Department of Energy
Washington, D.C. 20545

RESPONSES TO REQUEST FOR ADDITIONAL INFORMATION

Reference: Letters, P. S. Check to J. R. Longenecker, "CRBRP Request for Additional Information," dated April 9, April 30, and June 21, 1982

Enclosed are responses to Questions CS 421.37, 38, and 57, and CS 760.99, 178, and 179 which will also be incorporated into a future PSAR amendment.

Fig. QCS760.178A1-1 Comparison of PLUTO-2 Calculated Reactivity History for TREAT Test L8.

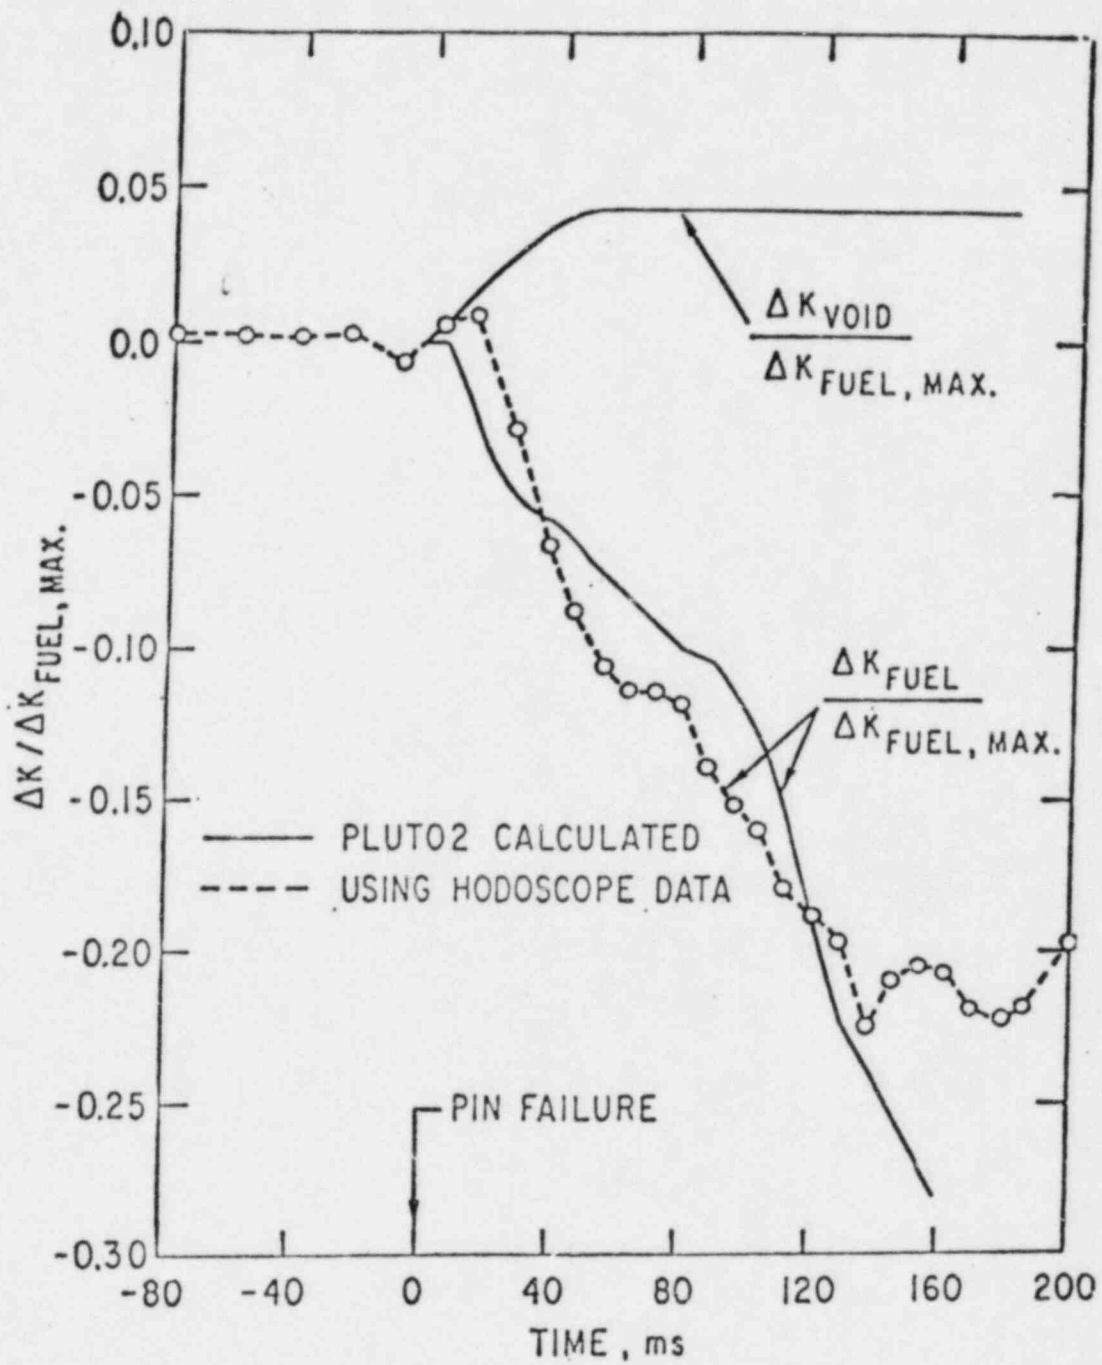
Can TOP accidents become prompt-critical in such a way that internal fuel motion in lower power channels is the key factor in the energetics determination? Is such an event possible only for midplane failures with low sweepout? How is the degree of sweepout determined? What is the effect of intrasub-assembly incoherence on sweepout?

In Fig. QCS760.178A1-1 normalized fuel reactivity histories of the measured and calculated fuel distributions are shown. These fuel reactivities are obtained by integrating the product of a fuel worth curve and the axial fuel distribution over the length of the pins. It is apparent from the figure that the significant fuel sweepout and dispersal which occurred in this test was well represented by PLUTO-2. According to the hodoscope results the fuel motion reactivity became negative about 20 msec after rod failure in this test (Ref. QCS760.178A1-6). The slight positive reactivity right after pin failure in the test data may be due to a lesser extension of the initial clad rupture above the midplane than assumed in the post-test simulation. However, this may also be due to the disregarding of the fuel self-shielding and can be altogether considered statistically insignificant when compared to earlier variations in the hodoscope reactivity curve.

Fig. QCS760.178B4-1 State of Core at Initiation of First Fuel Disruption (Ch. 11) for BOC-1 LOF Case 1C (Doppler = -20¢, Axial = -38¢, Sodium Void = -36¢, Cladding = 155¢, Net = 63¢, P = 2.33 Nominal).

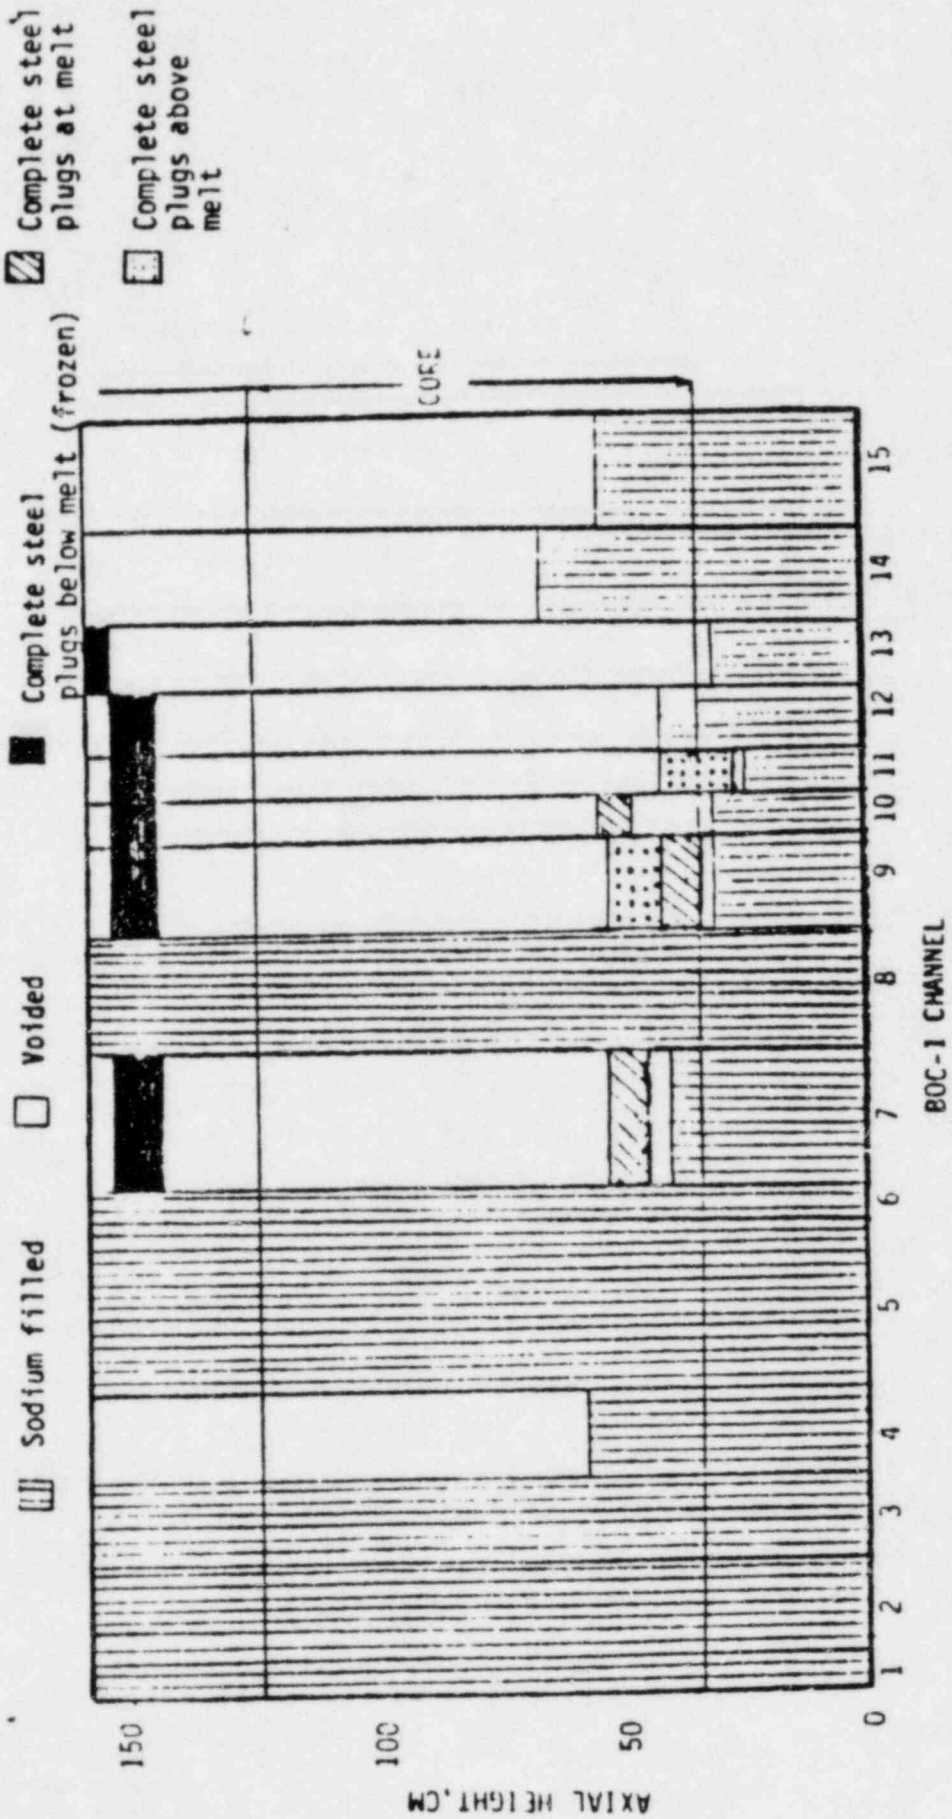
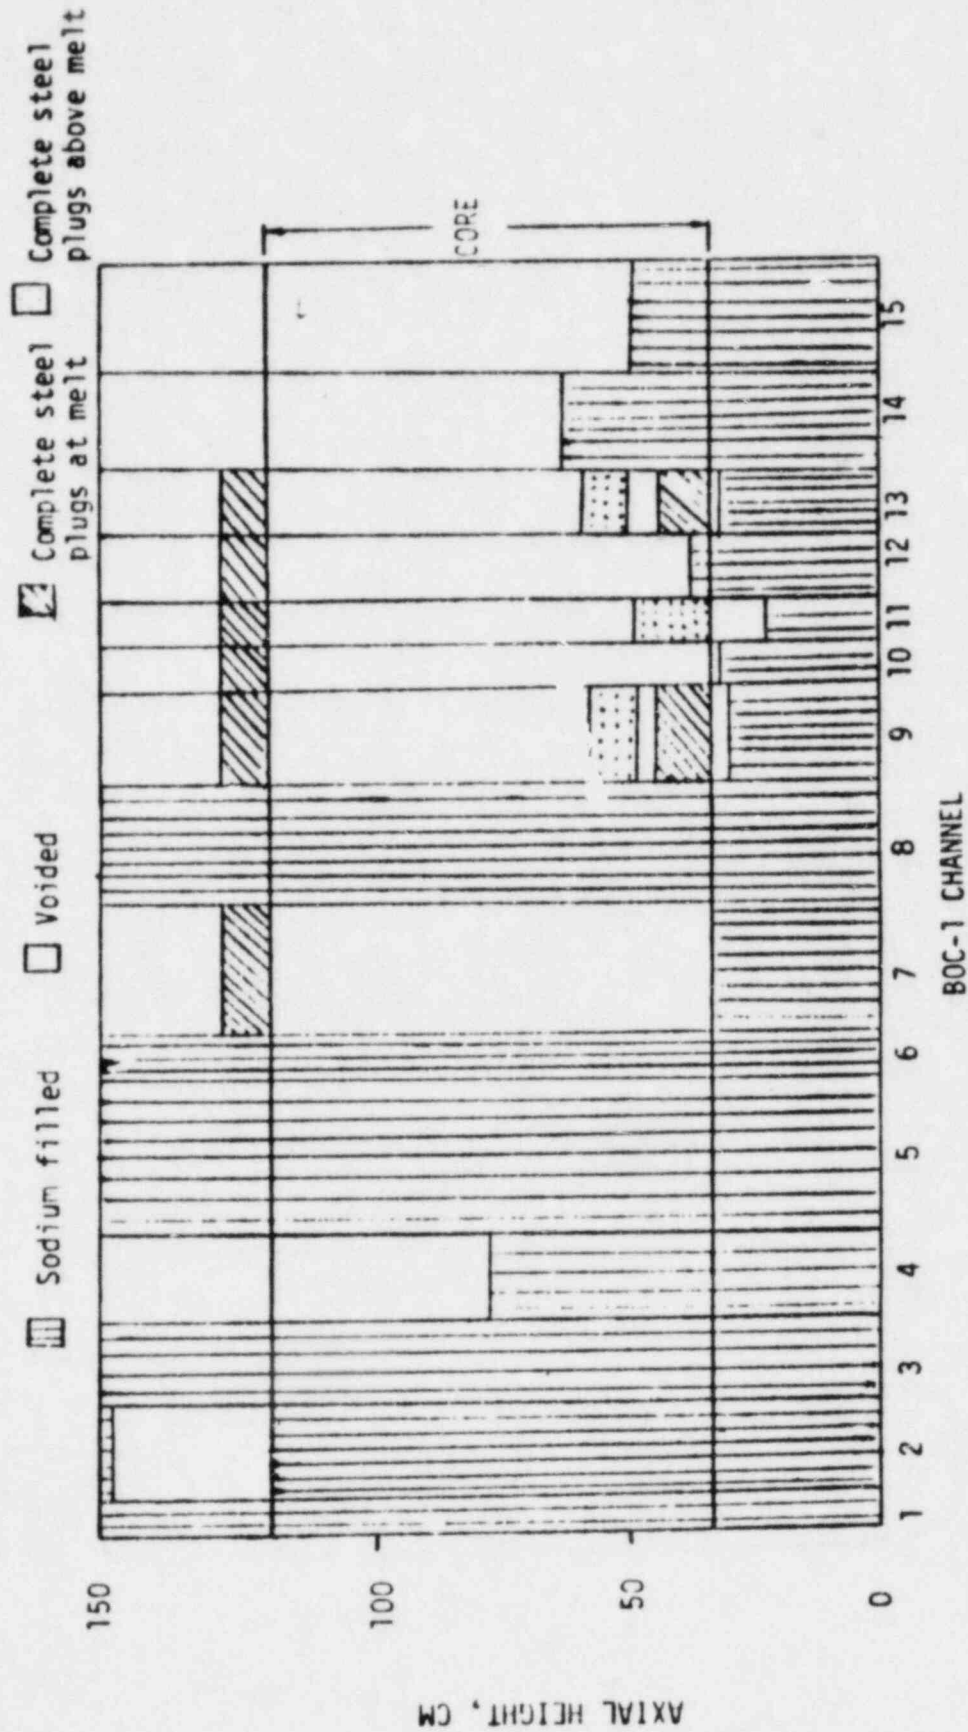
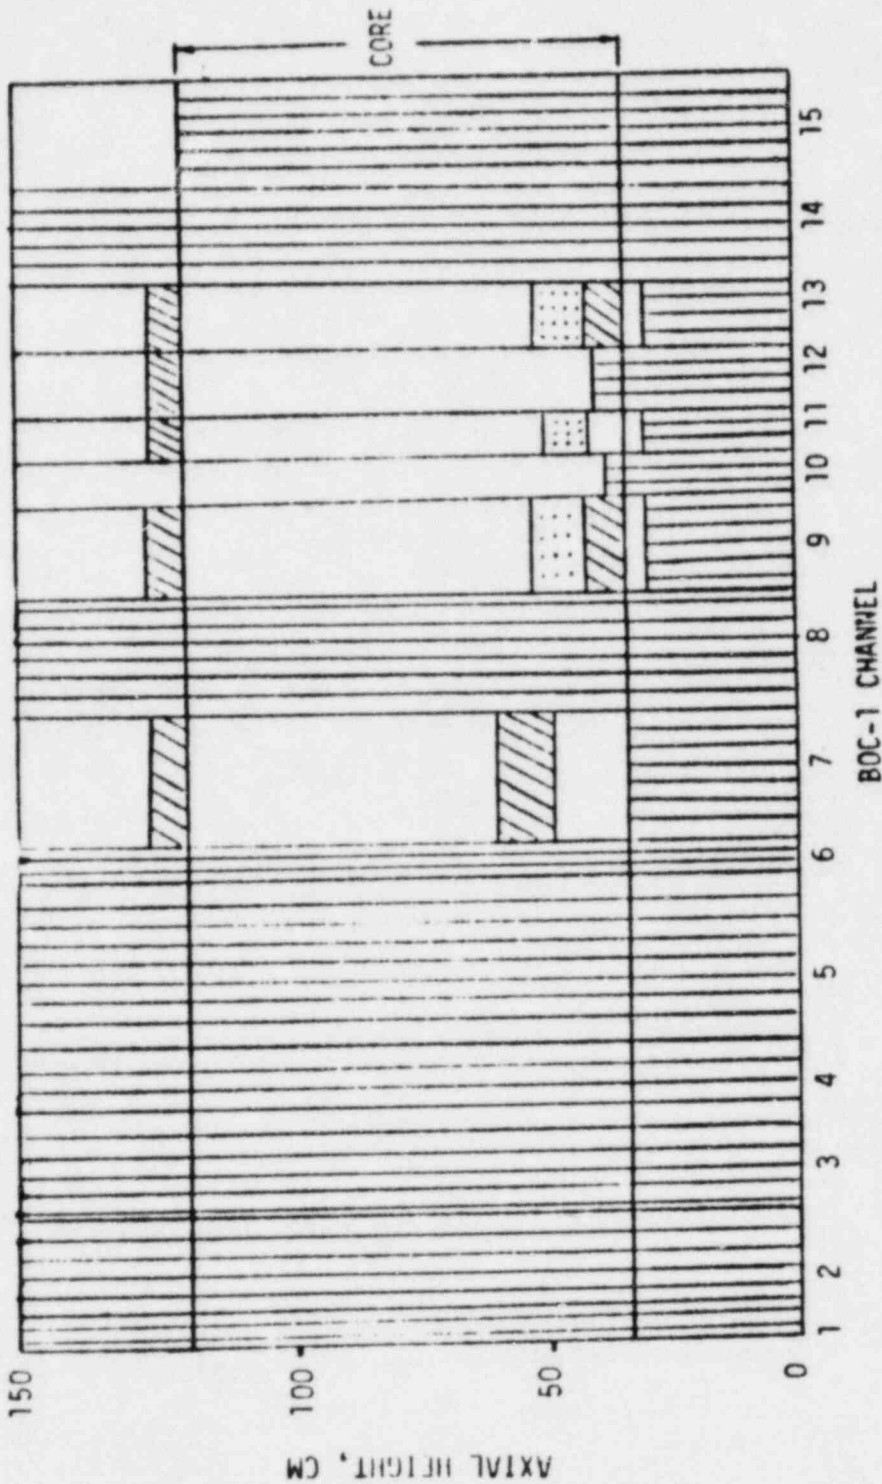
Question CS760.178B4

A significant time interval exists for molten cladding relocation during a loss-of-flow without scram event in the CRBRP. This is true for the entire core burnup cycle (i.e., BOC through EOC) and is principally the result of the very low effective sodium void worth of the heterogeneous design. However, very little upward steel relocation or blockage is expected for the irradiated core condition due to the blowdown of the high pressure plenum fission gas. The gas release opposes the sodium vapor streaming which is the primary mechanism for upward relocation of molten cladding (see response to QCS760.178A-3 for the CRBRP transient analysis). This gas release effect has been experimentally confirmed (Ref. QCS760.178B4-1) and results in only a thick lower steel blockage for irradiated core conditions.

In order to examine the axial location effect in the first analysis (labeled Case 4) the steel blockage was forced to form upon entering the upper axial blanket, providing the maximum restriction to fuel removal. The core transient response history and extent of steel blockages were found to be quite similar for the reference and modified axial blockage location. Figures QCS760.178B4-1 and -2 depict the core conditions at the onset of fuel motion in each analysis; very little independent steel relocation occurs after this event. Based upon the mechanism of near-fresh fuel melting and drainage, a power burst occurs (comparable to Case 1C) which disperses fuel and leaves the core in a subcritical but higher reactivity state. The peak fuel thermal conditions in the fuel channels which did not disrupt are reasonably similar as shown in Table QCS760.178B4-1. Hence, the CRBRP core dynamic behavior was found to be only weakly affected by the steel blockage axial location. The same extent of steel blockages throughout the core was found to exist upon melt-out phase initiation. In addition to locating the steel blockage at the entrance to the UAB, uncertainties in reactivity parameters were also represented in a manner to slow down the transient response, and thereby allow

Fig. QCS760.178B5-1 Sketch Showing the Interstitial Gaps Outside and Below the Core Region.

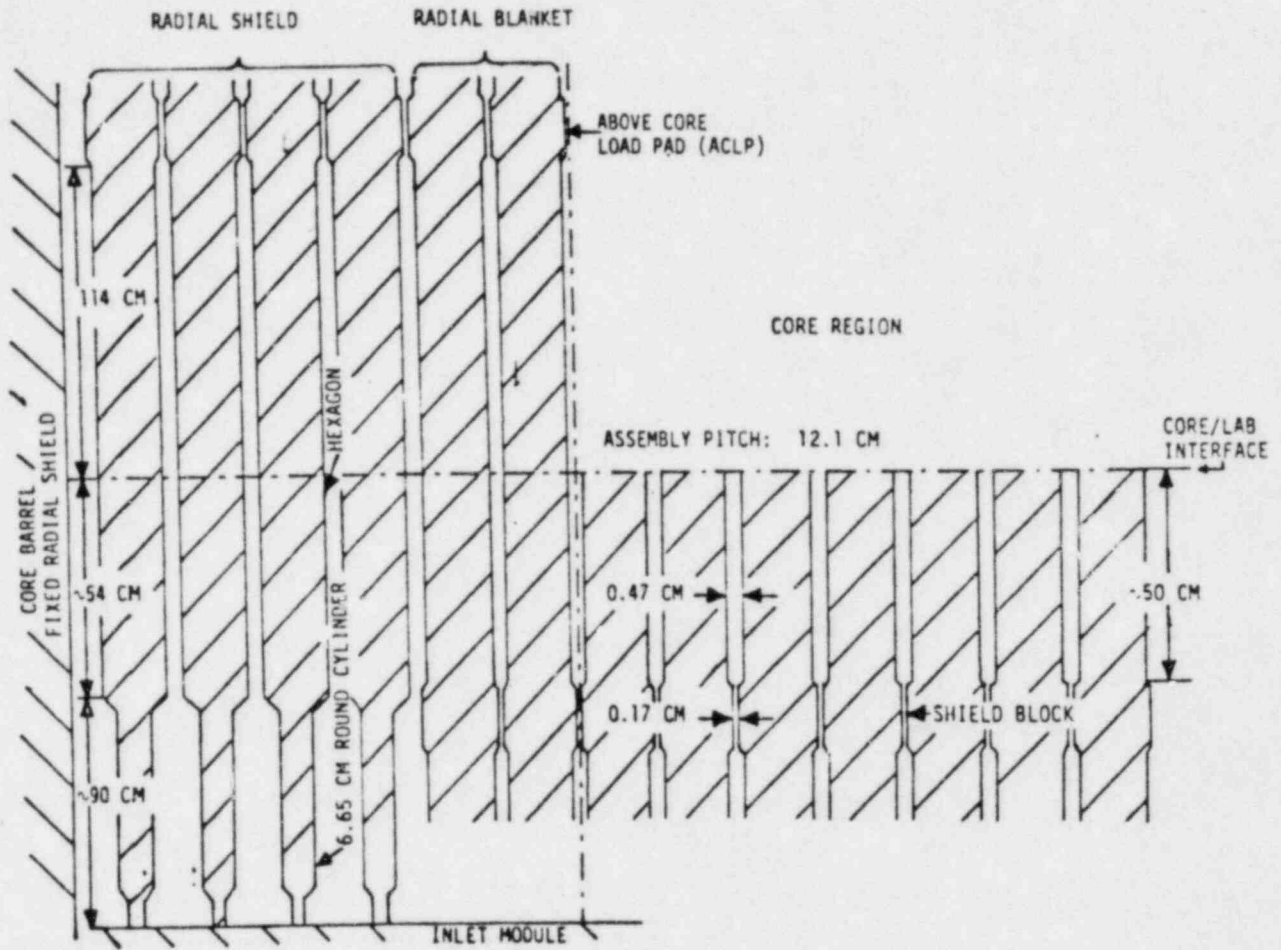
Question CS760.178B5, -C6, -C7

Interassembly Gaps - Figure QCS760.178B5-1 shows the side view of the gaps in the region below the core, and the radial blanket/shield regions. The dimensions shown in this figure are fabrication dimensions at room temperature. Although the gap sizes could be larger in actual cases due to thermal expansion, the fabrication dimensions are used in the present estimation of the gap volume. Furthermore, it is assumed that the gaps in and below the shield block region (.17 cm) will not be available due to fuel plugging as it flows into this constricted region.

Fig. QCS760.178D8-1 Axial Force vs. UIS Axial Displacement.

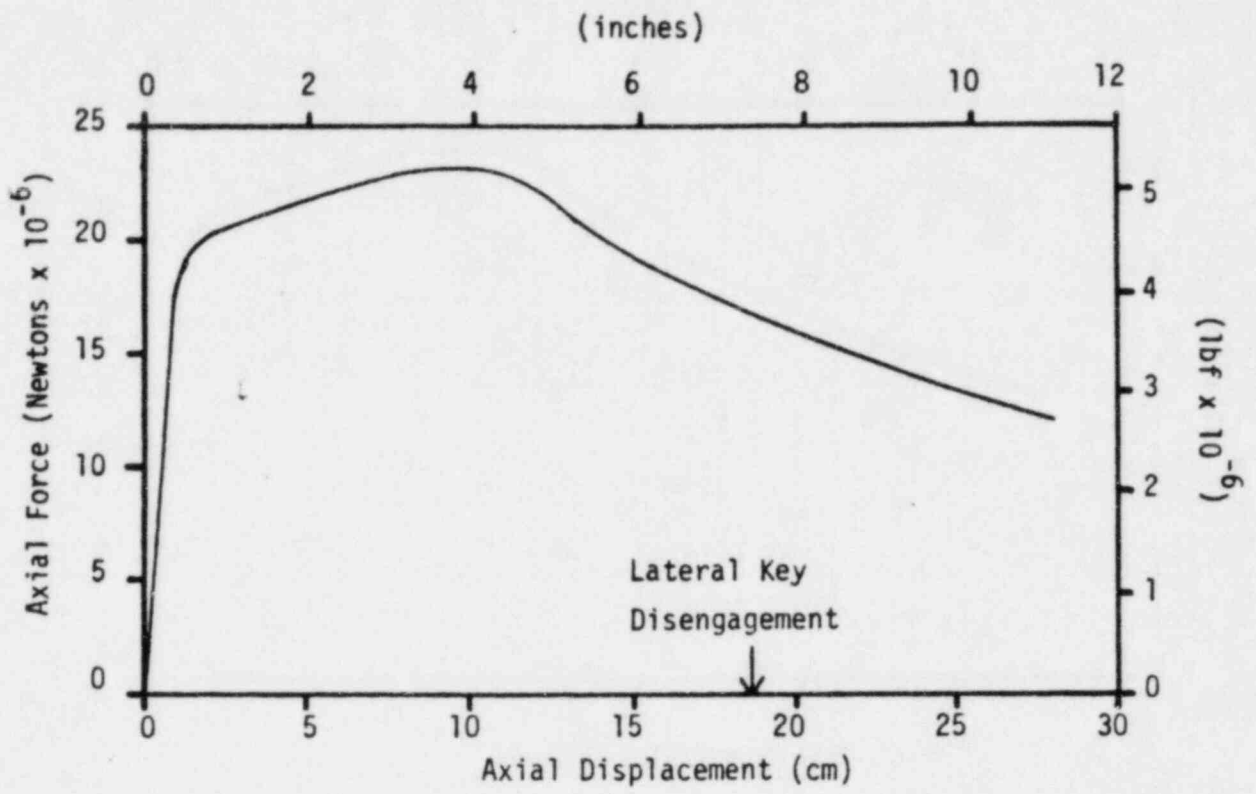
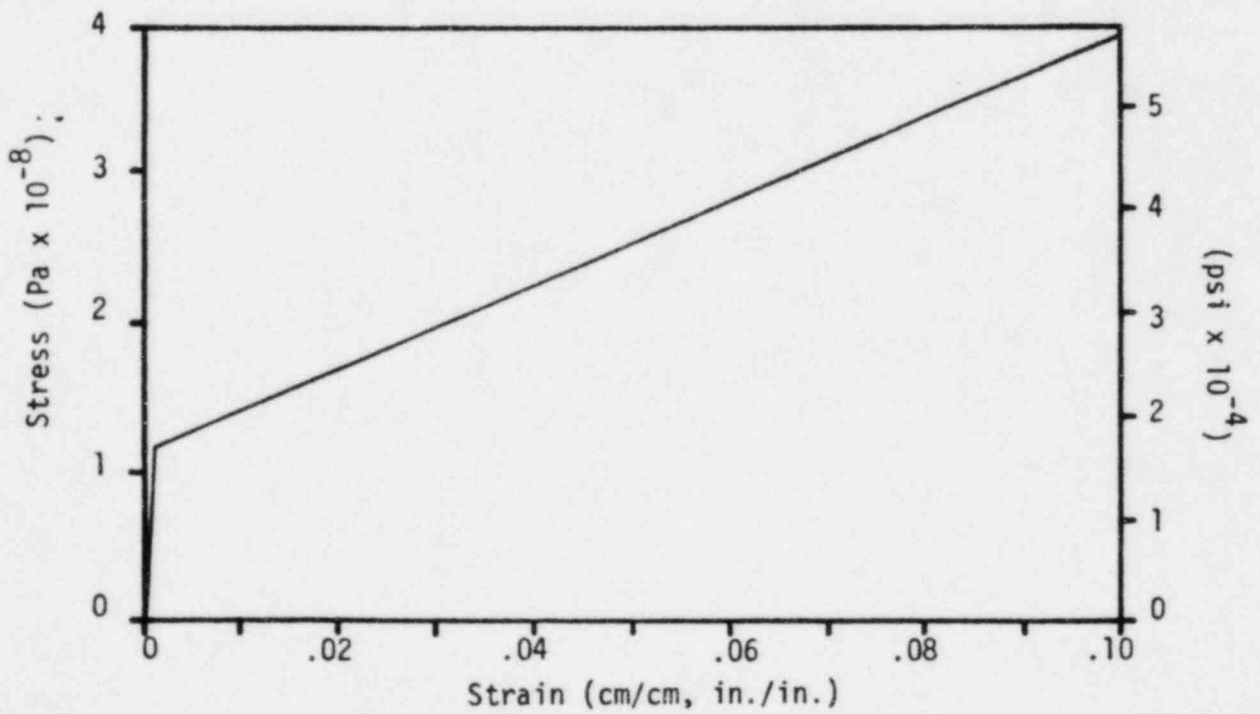
Question CS760.178D8

One way to help characterize the above force required to buckle the UIS columns is to assume that all of the above core structural flow paths are blocked, and that the structure is lifted up against the bottom of the UIS by a uniform core pressure. For this assumed configuration, the required pressure is calculated to be approximately 91 atm.

The ANSYS model utilizes plastic pipe elements for the support columns and elastic shell elements for the UIS structure. The columns are modeled with a slight initial deformation, which in combination with the geometry updating procedure allows column buckling to be analyzed. Figure QCS760.178D8-1 shows the resulting estimate of vertical force on the UIS versus vertical displacement. This result utilized a minimum yield stress of 1.17×10^8 N/m² and resulted in a maximum axial load of 2.32×10^7 N where column buckling occurred. Assuming a maximum value for the yield stress (Ref. QCS760.178D8-3), a maximum axial load of 5.03×10^7 N is expected when column buckling would occur. Figure QCS760.178D8-2 provides the bilinear stress-strain relationship used for 316 SS at 538°C in the ANSYS model. The bilinear curve is very good for strains below 0.05 and within 15% of expected values (Ref. QCS760.178D8-1) for strains below 0.10. Hence, a force of approximately
